The starter drives ZEN 0837 and 0482 are similar in dimensions, but there is a difference in the force of the spring. See below:

0837

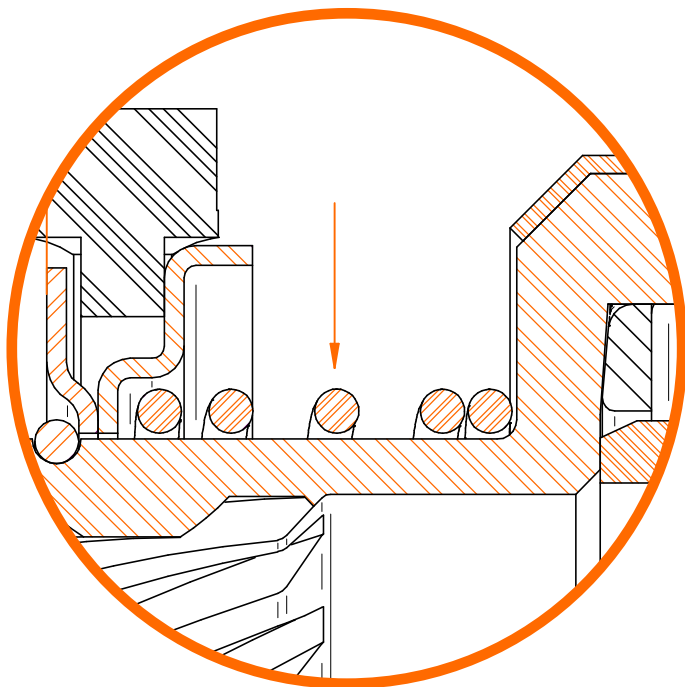
• These drives are not interchangeable, because the spring force of the drive 0482 is greater than the one found on the drive 0837.
